RE: 2960 St. Gregory Road, PVAR 2002984

The Glendale Historical Society is grateful for the opportunity to comment on the request for two variances for the project at 2960 Saint Gregory Road as well as the proposed Class 3 Categorical Exemption from CEQA under Section 15303.

Figure 2a. Aerial view of property outlined in blue dated 2022. Source: Office of the Los Angeles County Assessor. Property Portal.

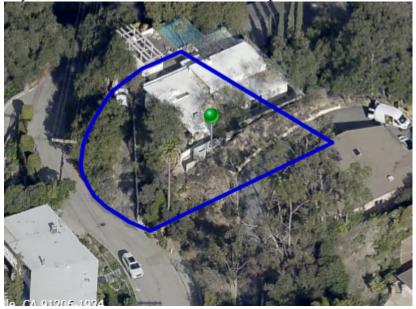
the color difference is based on different paint colors. The vague description of louvre screens that were removed or, more likely, not constructed is likewise not proven. Figures 2a and 2b do show Modern overhanging "eyebrows" on what is described as the "primary façade." In addition, the described replacement of sliding doors with "modern flush mounted glass doors," which appear to have black metal extrusions rather than clear aluminum extrusions, with no permit, is a further exaggeration that likely would not affect the building's integrity (page 4). No building permits or other real evidence for any of the described alterations were provided.

As described above and depicted in Figures 2a and 2b, there is nothing in the subject property building permit records or the photos provided to suggest significant alterations that would diminish the property's eligibility. However, a 2,300 square-foot, one- and two-story addition to an 1,876 square foot, single-story residence that may cause an impact on a historic resource should be fully analyzed.
